EPC STORMWATER REVIEW COMMENTS
IN ORANGE BOXES WITH BLACK TEXT

GRANDVIEW RESERVE FILING NO. 1

GRADING & EROSION CONTROL PLANS

SF2311

G3.2

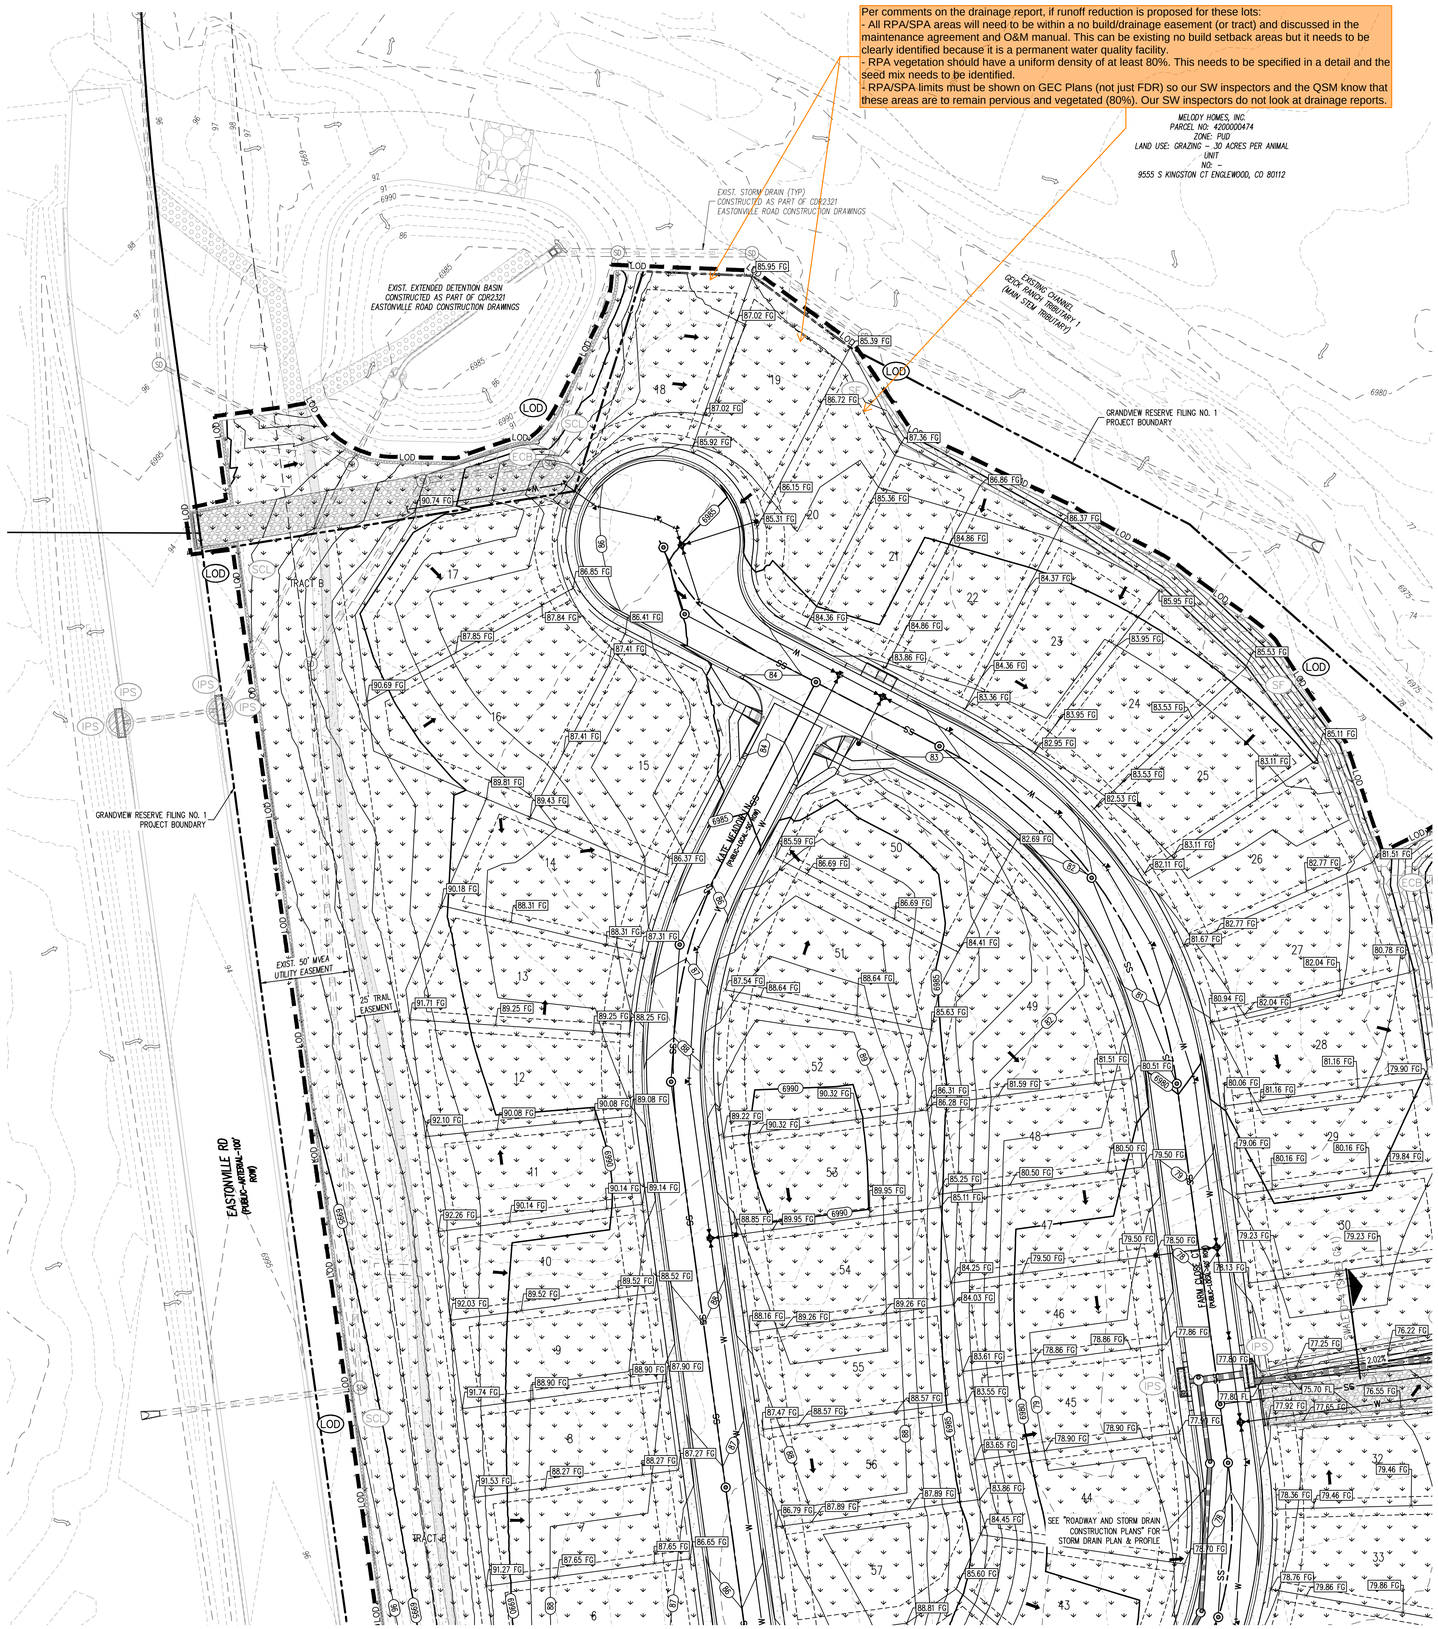
Per comments on the drainage report, if runoff reduction is proposed for these lots:
- All RPA/SPA areas will need to be within a no build/drainage easement (or tract) and discussed in the maintenance agreement and O&M manual. This can be existing no build setback areas but it needs to be clearly identified because it is a permanent water quality facility.
- RPA vegetation should have a uniform density of at least 80%. This needs to be specified in a detail and the seed mix needs to be identified.
- RPA/SPA limits must be shown on GEC Plans (not just FDR) so our SW inspectors and the QSM know that these areas are to remain pervious and vegetated (80%). Our SW inspectors do not look at drainage reports.

STORM DRAIN LINE PROFILE: SD-D-POND OUTFALL 1 (WEST) (STA: 0+75 – 4+40)

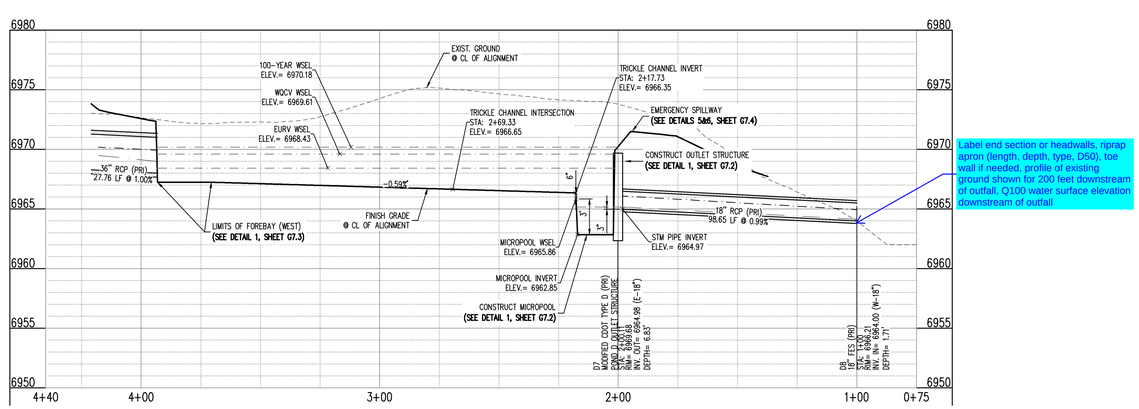
Label end section or headwalls, riprap apron (length, depth, type, D50), toe wall if needed, profile of existing ground shown for 200 feet downstream of outfall, Q100 water surface elevation downstream of outfall
